## **RFP #2025-07**

### **ADDENDUM #2**

**Issued 4/11/25**

Your attention is directed to the following interpretations of, changes and additions to the Contract Documents for the project, “Air Cargo Road Overflow Parking Lot & Maintenance Employee Lot” at Syracuse Hancock International Airport.

C100

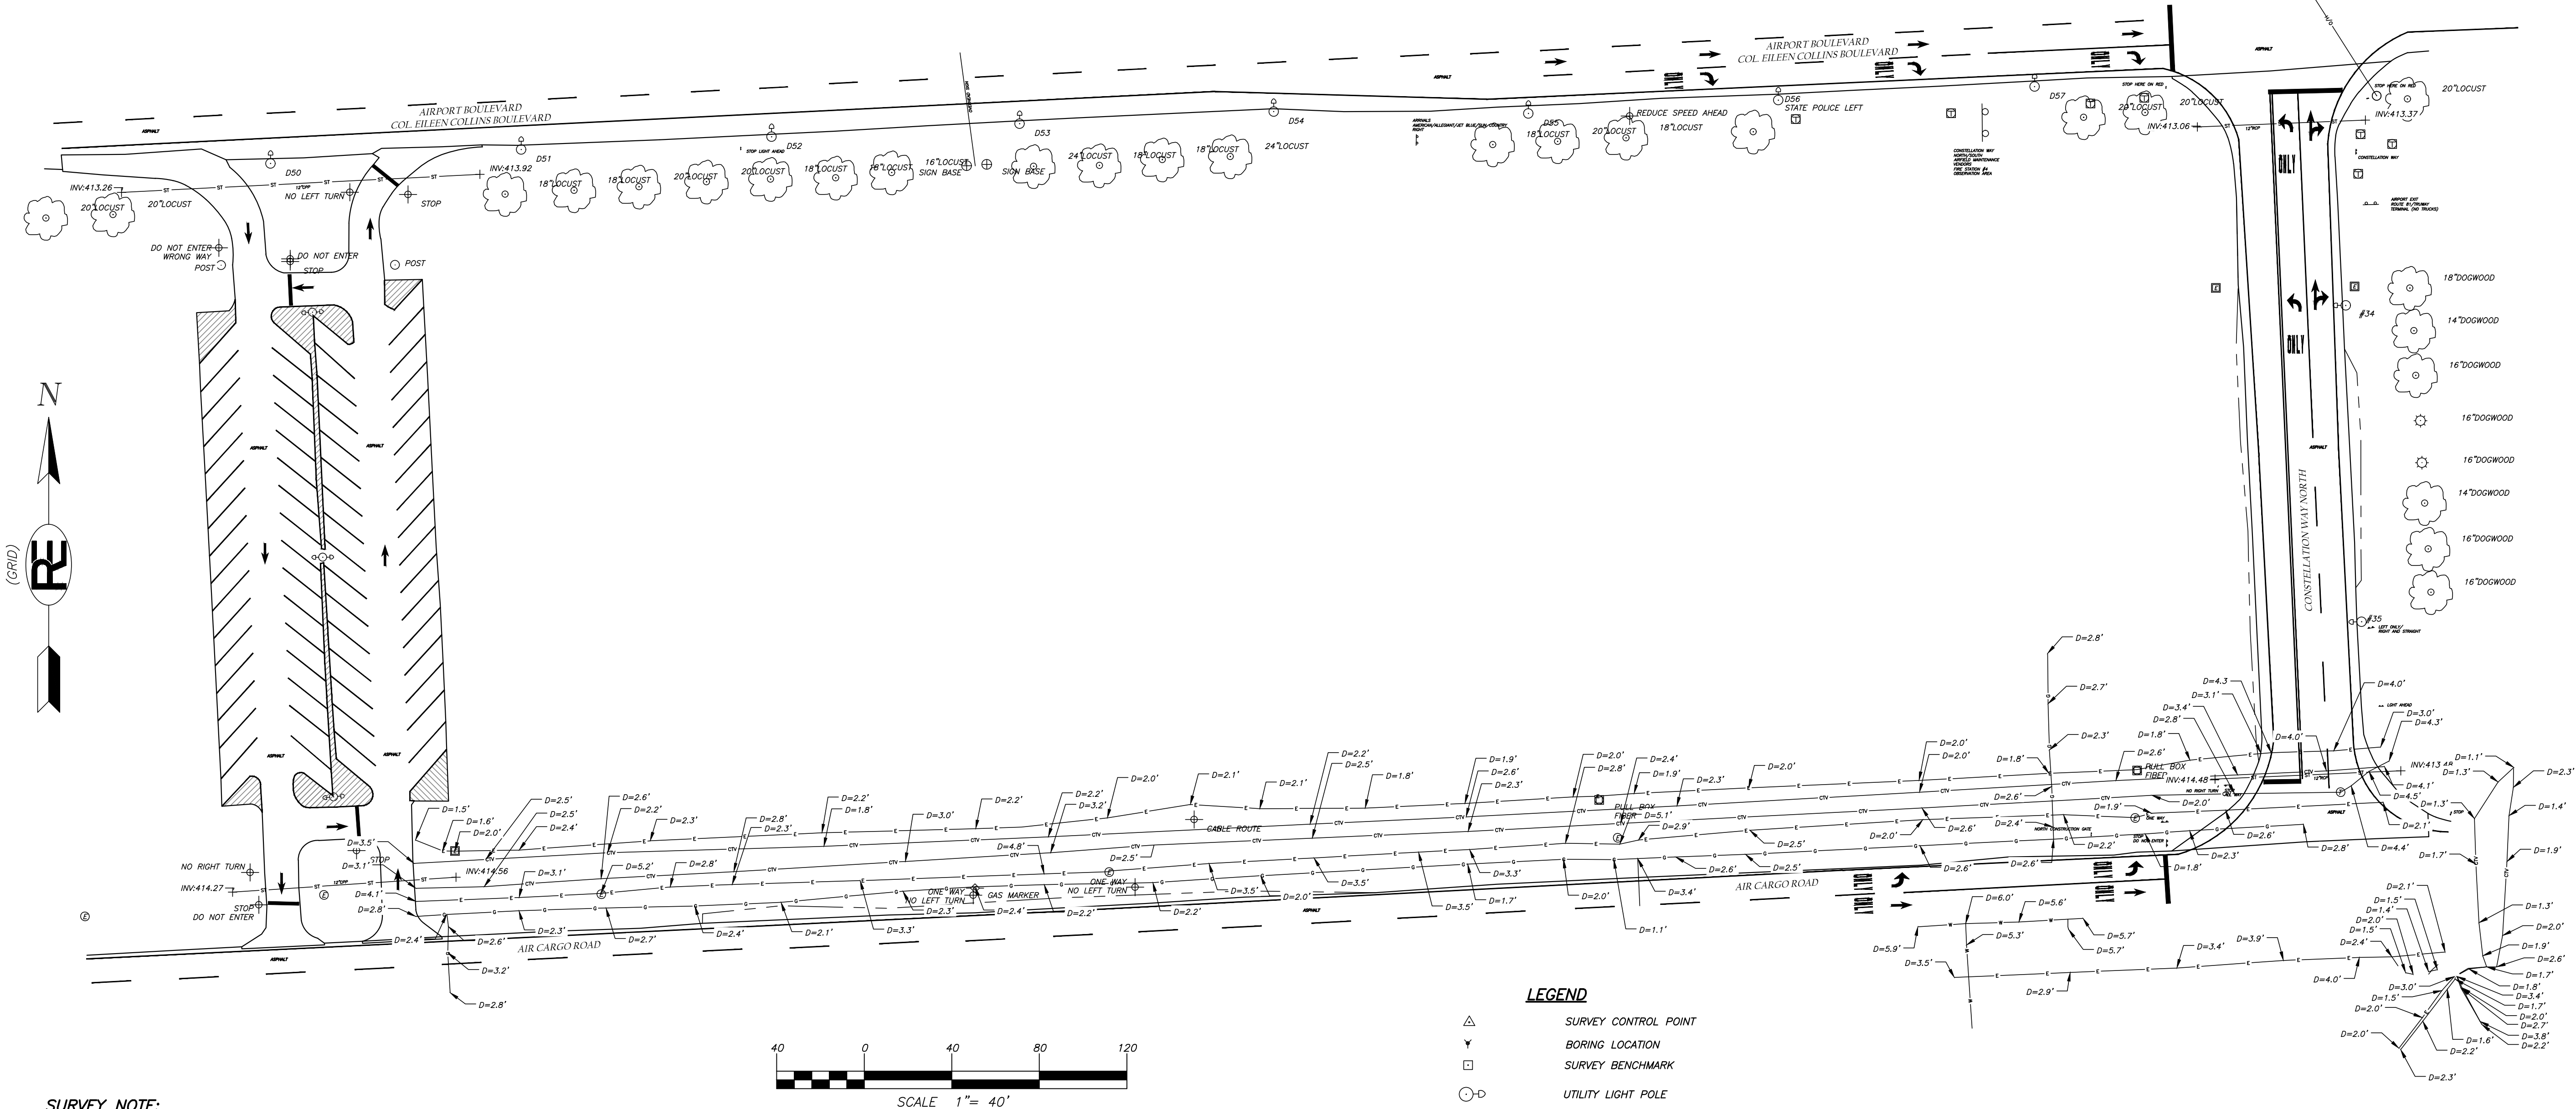
1. Revision: C100
  - Revised sheet list table with additional sheets and corresponding sheet number changes.
  - Revised quantity table to update items associated with Air Cargo Road to be two-way.
2. Addition: C104
  - Existing subsurface utility designation survey sheet added.
3. Revision: C301
  - Revision to roadway signage and striping to be removed.
4. Addition: C302
  - Offsite demolition plan added to reflect additional demolition items associated with the conversion of Air Cargo to two-way for the entire length of the roadway.

C301

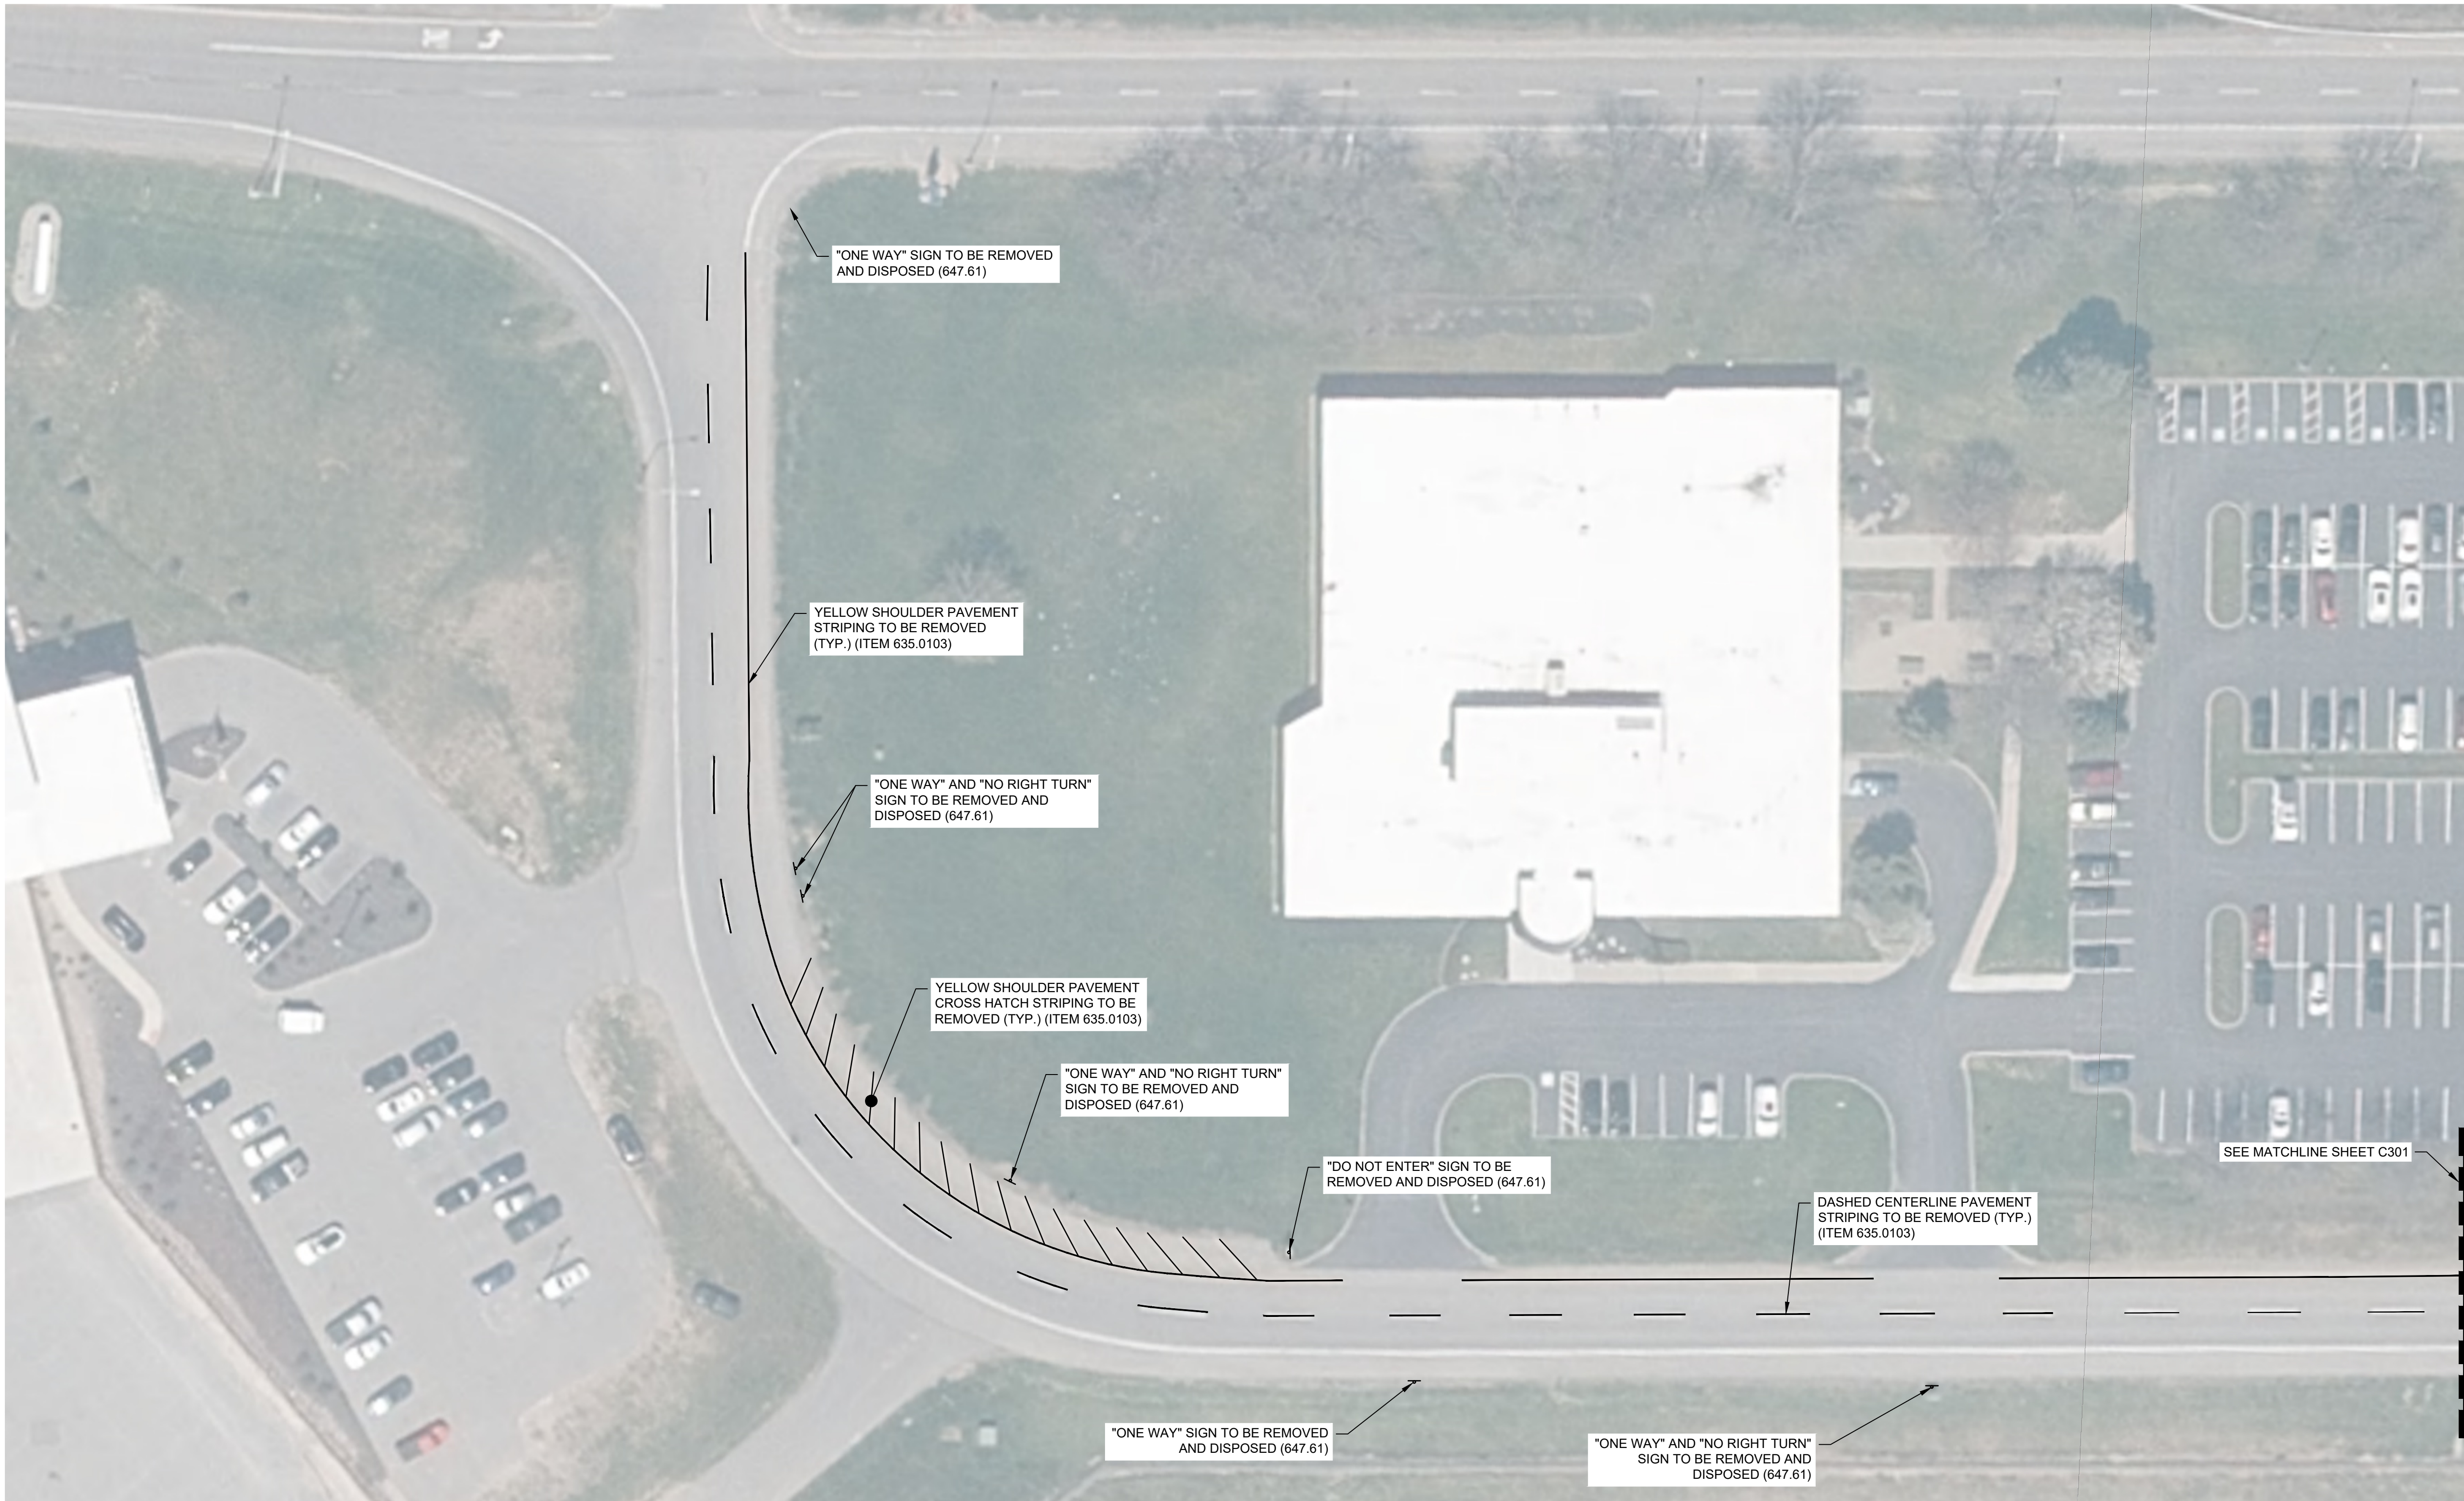
"ONE WAY" SIGN TO BE REMOVED AND DISPOSED (647.61)

"ONE WAY" AND "NO RIGHT TURN" SIGN TO BE REMOVED AND DISPOSED (647.61)

C305

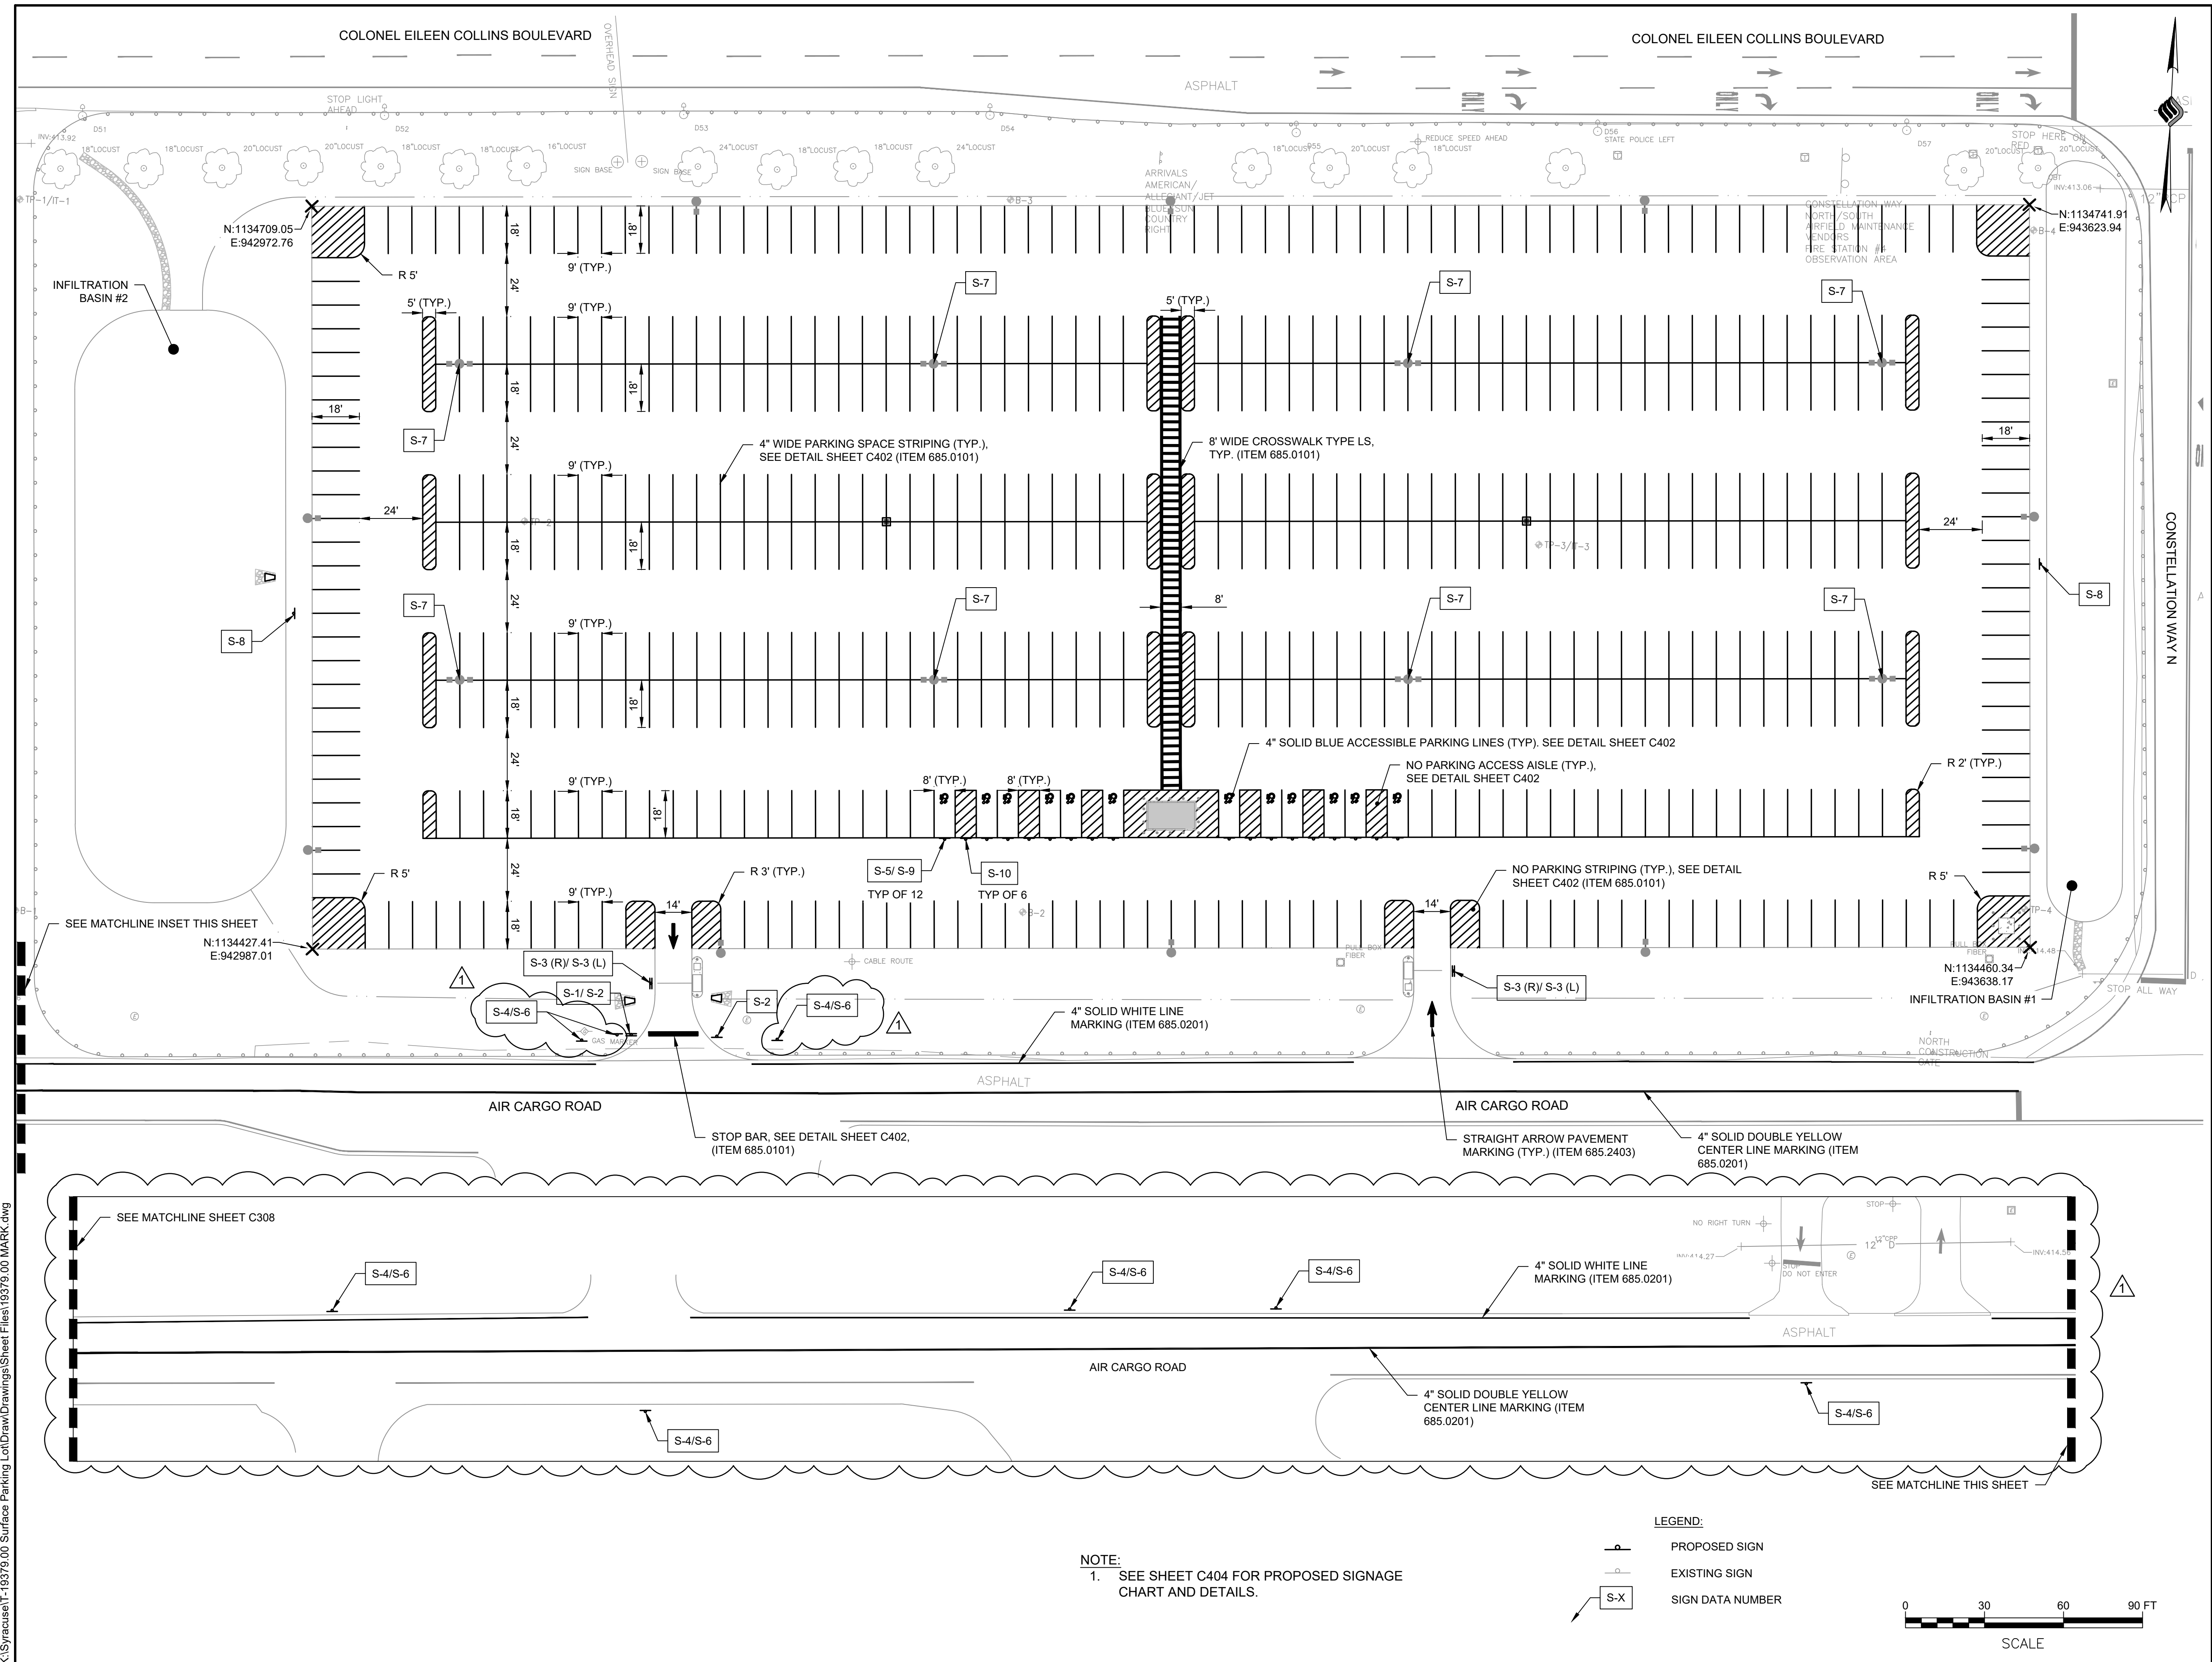
5. Revision: C303
  - Revision to roadway signage and striping.
6. Revision: C305
  - Subsurface utility depths added to the grading and drainage plan.
7. Revision: C307
  - Revision to roadway signage and striping.
8. Addition: C308
  - Offsite signage and striping plan added to reflect additional signage and striping items associated with the conversion of Air Cargo to two-way for the entire length of the roadway.
9. Revision: C309
  - Subsurface utility depths added to the utility plan. Light poles LP-1, LP-2 and LP-3 repositioned to not conflict with existing utilities.
10. Revision: C404
  - Signage table chart updated to signage changes and additions along Air Cargo Road.
